# Groundwater Application Review Summary Form

Application # G- 19311

GW Reviewer Grayson Fish Date Review Completed: 3/3/2025

Water-Level Measurements in Nearby Wells

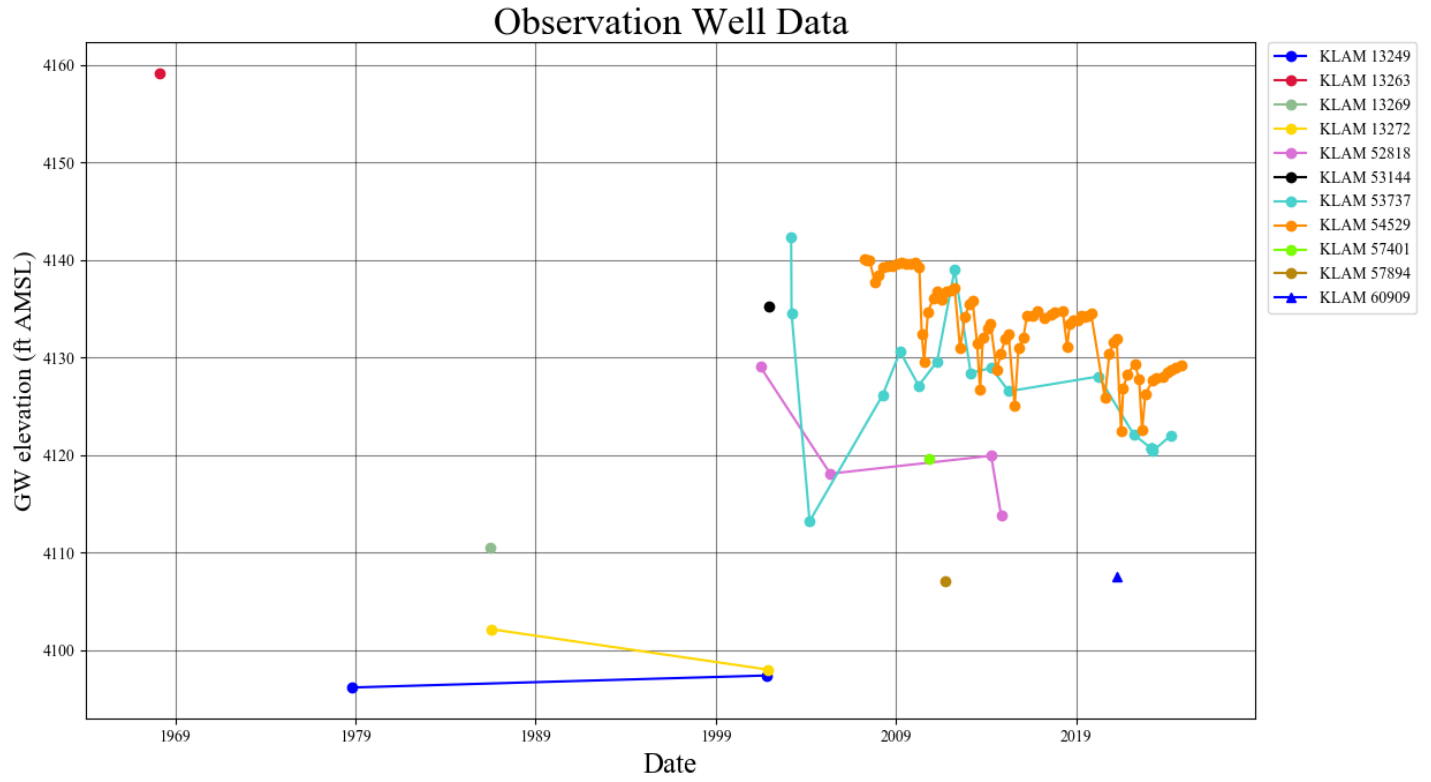
The only available water level data for KLAM 13269 is a July 1, 1986 measurement from the well log submitted at the time of construction. The water level at the time and the lithology recorded in the well log suggest that the well sources water from the shallow sedimentary rocks and volcanic sediments overlaying the basalts/volcanic at depth (See attached hydrograph and well log). Given the lack of water level data from nearby wells which source water from the sedimentary unit, it is recommended that additional data be collected from KLAM 13269 if a permit were to be issued.

The applicant’s proposed POA is located within the Bureau of Reclamation’s Klamath Project area of the Upper Klamath Basin. Wells throughout this area have experienced long term-water level declines associated with increased groundwater pumping during drought years when Project surface water deliveries have been shut off or reduced. The nearby domestic observation well KLAM 54529, which sources water from basalt/volcanics at depth, has experienced approximately 12 feet of groundwater level declines since measurements began in 2007, with 6.60 feet of decline observed between 2019 and 2023 when comparing annual high-water levels. These year-over-year declines associated with drought years and annual highs that do not recover to previous levels suggest that groundwater storage in the area is being depleted. The highly transmissive volcanics and the overlying low transmissivity sedimentary units are hydraulically connected, albeit with an attenuated pressure response. **If proposed groundwater use were to commence as described in this application, it would further contribute to observed groundwater level declines in this portion of the basin and potentially lead to permit decline conditions triggering on existing rights. This would preclude the perpetual use of the aquifer by limiting the use of existing water right holders and, therefore, groundwater for the proposed use will not likely be available within the capacity of the resource.**

**Hunt (1999) Model – Stream Depletion**

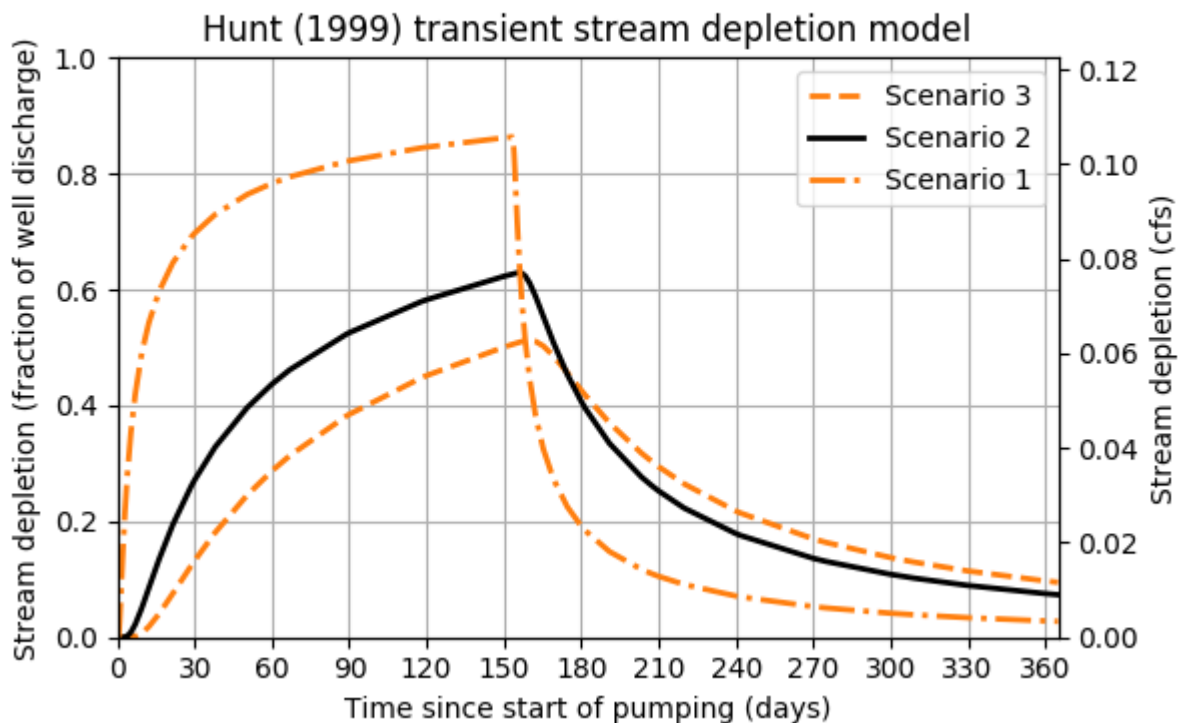
**Comments:** The Hunt (1999) model was used to estimate the degree of stream depletion that may occur if use were to proceed under this application. Transmissivity and storativity values for the tertiary sedimentary unit was sourced from Ground-Water Hydrology of the Upper Klamath Basin, Oregon and California (Gannett et. al., 2007). The Hunt (1999) model estimates between 13 to 70% stream depletion value at 30 days using a transmissivity value of 200 ft<sup>2</sup>/day and storativity values ranging from 0.003 to 0.0002 and 27% stream depletion when a transmissivity value of 0.0016 (mid-point of the range) is used. Using a preponderance of the evidence standard (51% certainty), groundwater use from the proposed POA is likely to result in stream depletion greater than 25% by 30 days of use. Nuss Lake is located less than 1/4-mile from the proposed POA which sources water from an unconfined aquifer and results in a finding of assumed potential for substantial interference under OAR 690-009-0040(2).
